PRODUCT CHANGE NOTIFICATION

#PCN-ICC-HL1H-15

Business Unit	Product Line Code	Type of Change	Action	Date of issue
ICC	BE1	Mechanical	Notify Distributors and Field	2/2/2015

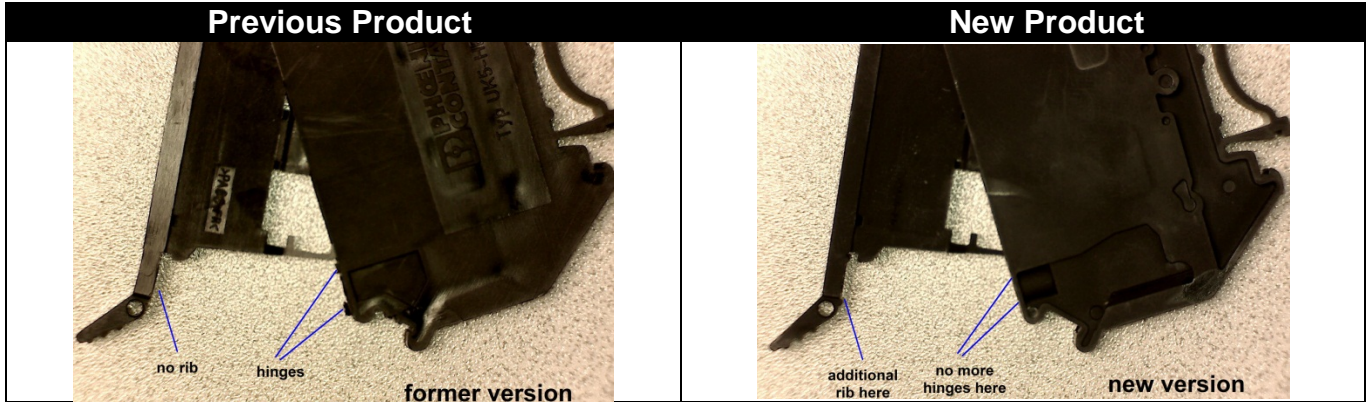
Housing of the fuse lever has been slightly modified due to production reasons. Small hinges had been removed and ribs added at the opposite side (fuse carrier). Function is not affected. More solidly defined snap-in available now. Old and new versions are still being produced and can be used together.
